FLRD #2 LLC

PHASE II REGIONAL WATER IMPROVEMENTS 0.26 MG POTABLE WATER TANK

PPR V_1 redlines.pdf Markup Summary

FLRD #2, LLC.
PHASE II REGIONAL WATER IMPROVEMENTS
0.26 MG POTABLE WATER TANK
FEMA FLOODPLAIN MAP

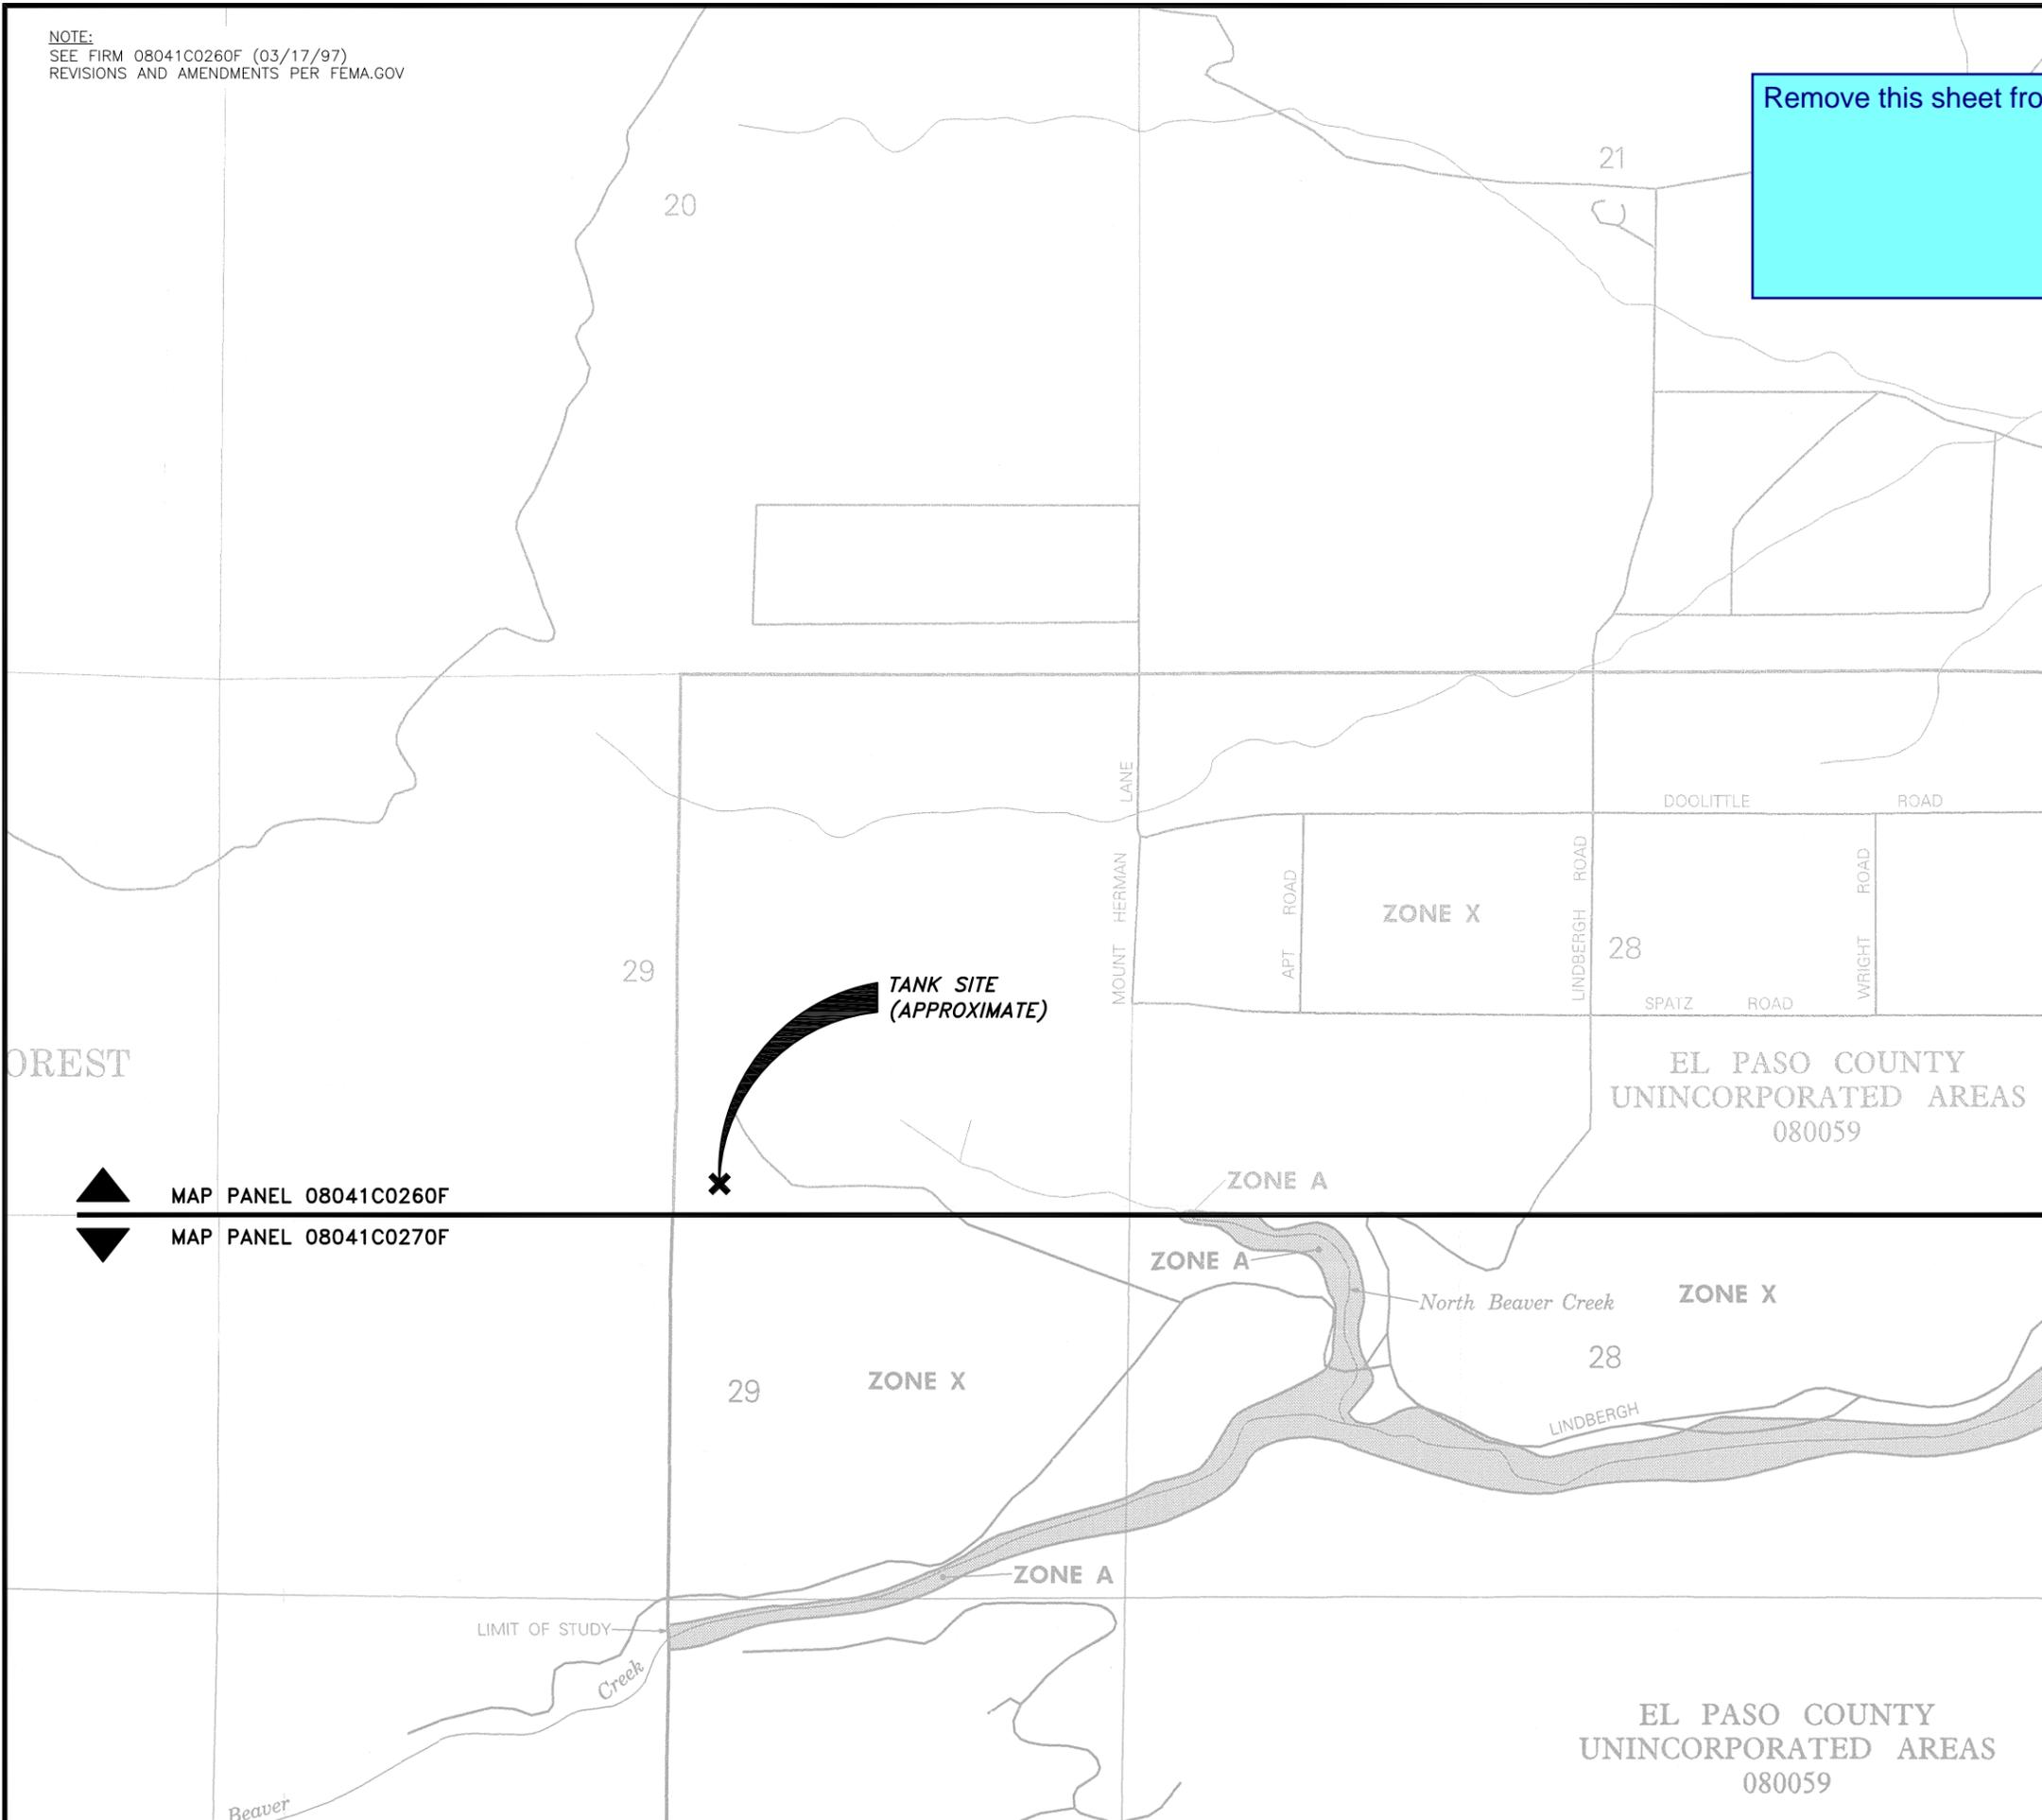
Remove this sheet from the site development plan

C1
 SHEET 4 OF 11

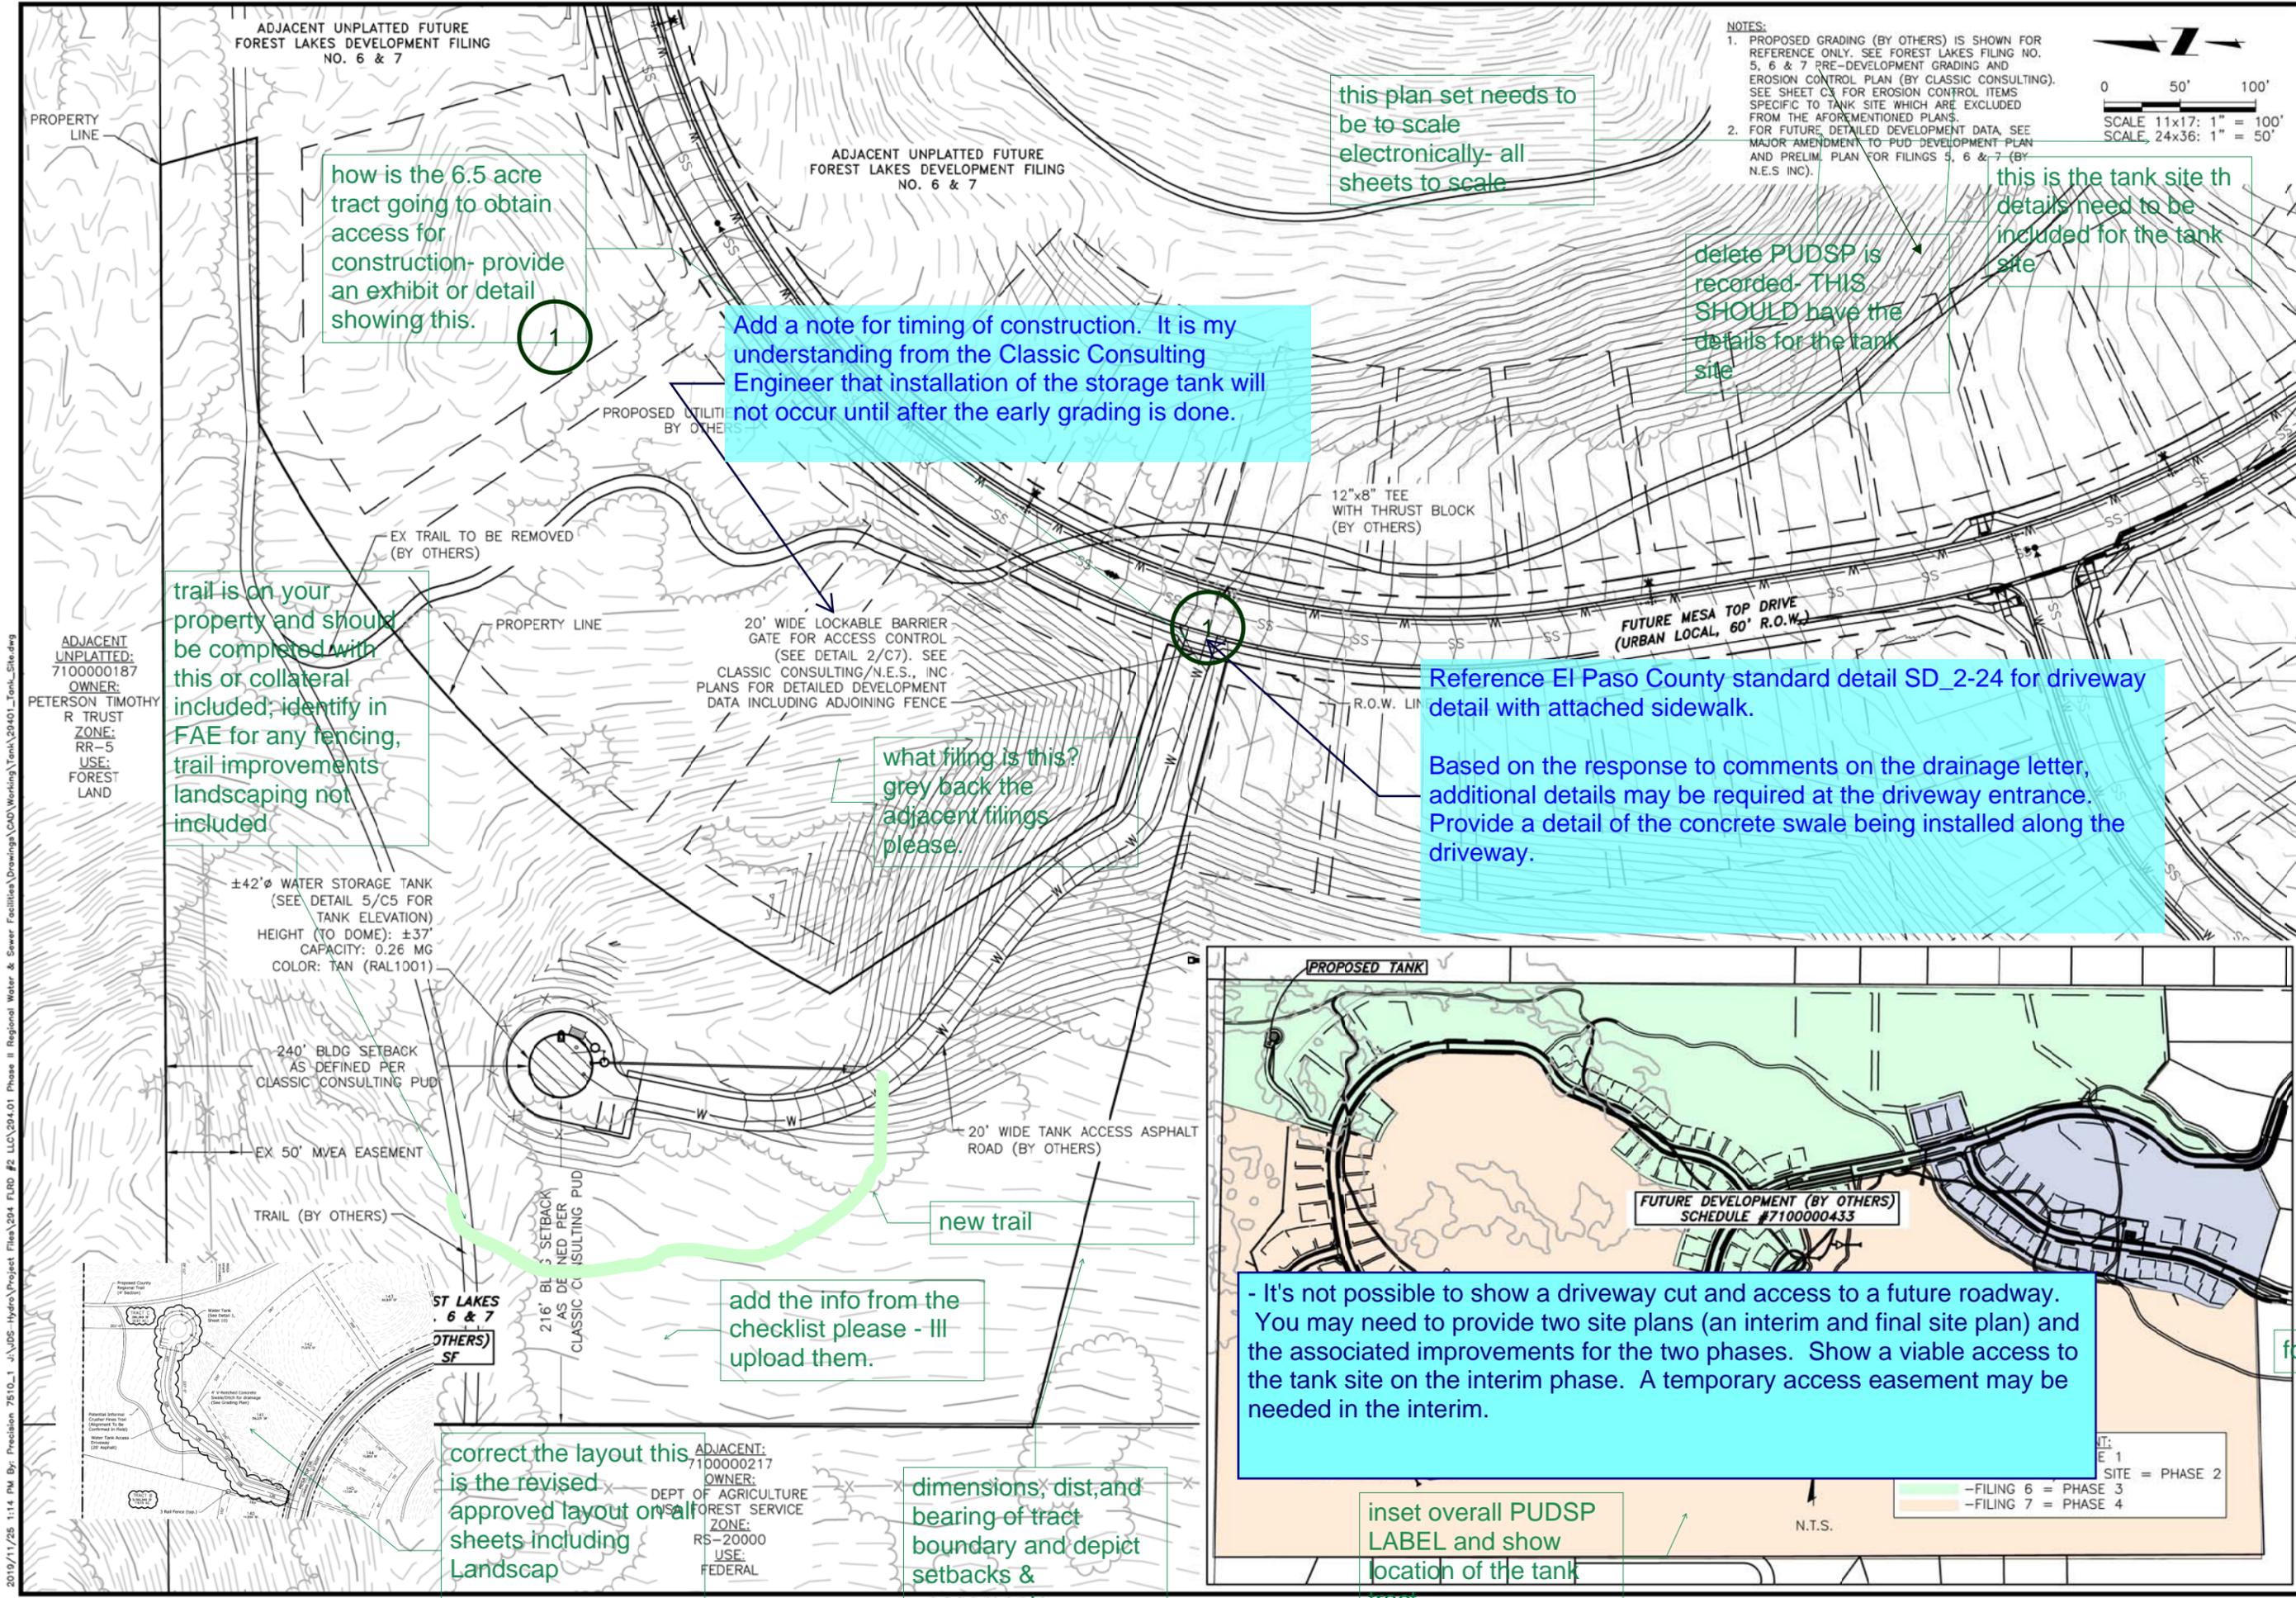
be detailed with vegetation to be removed and to be protected on landscape plan....provide the temp fencing to protect vegetation on landscape plan (3 fence details: temp, split, and chain)

this should be on first o second sheet instead of PPRBD info that isnot applicible to a site dev plan.

- It's not possible to show a driveway cut and access to a future roadway. You may need to provide two site plans (an interim and final site plan) and the associated improvements for the two phases. Show a viable access to the tank site on the interim phase. A temporary access easement may be needed in the interim.

C3
 SHEET 6 OF 11

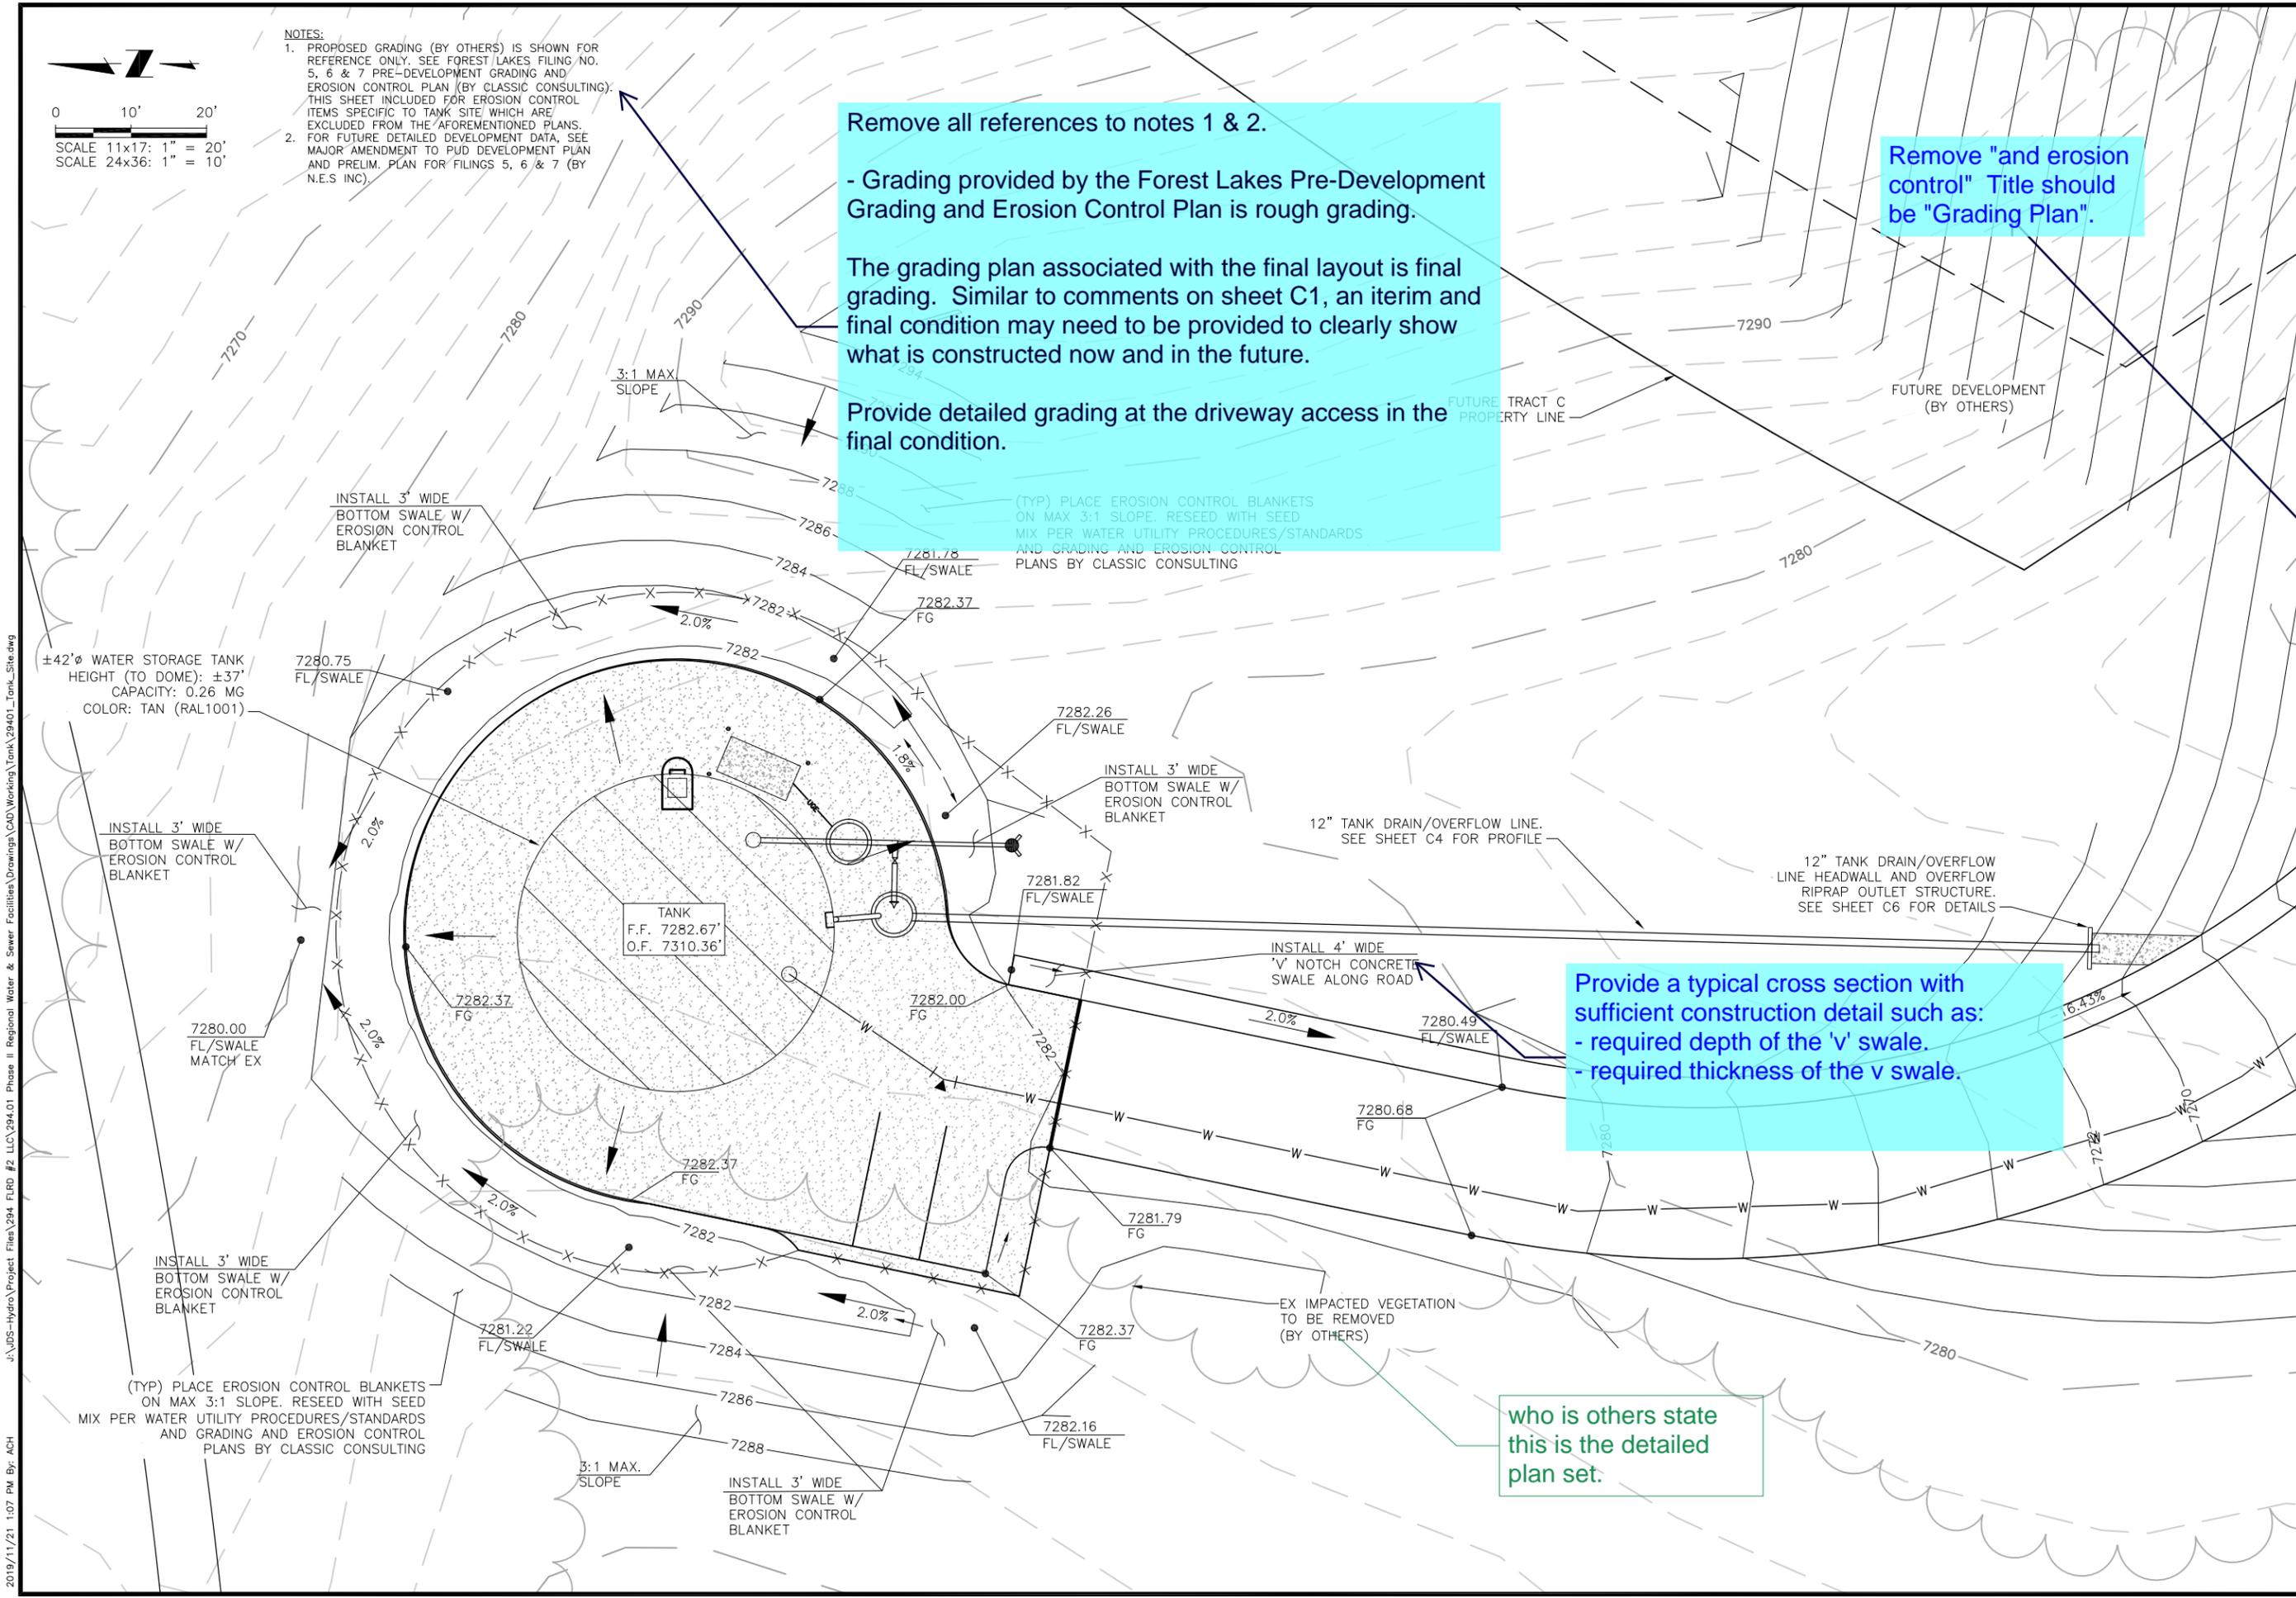
Remove all references to notes 1 & 2.

- Grading provided by the Forest Lakes Pre-Development Grading and Erosion Control Plan is rough grading.

The grading plan associated with the final layout is final grading. Similar to comments on sheet C1, an iterim and final condition may need to be provided to clearly show what is constructed now and in the future.

Provide detailed grading at the driveway access in the final condition.

Remove "and erosion control" Title should be "Grading Plan".

Provide a typical cross section with sufficient construction detail such as:
 - required depth of the 'v' swale.
 - required thickness of the v swale.

who is others state this is the detailed plan set.
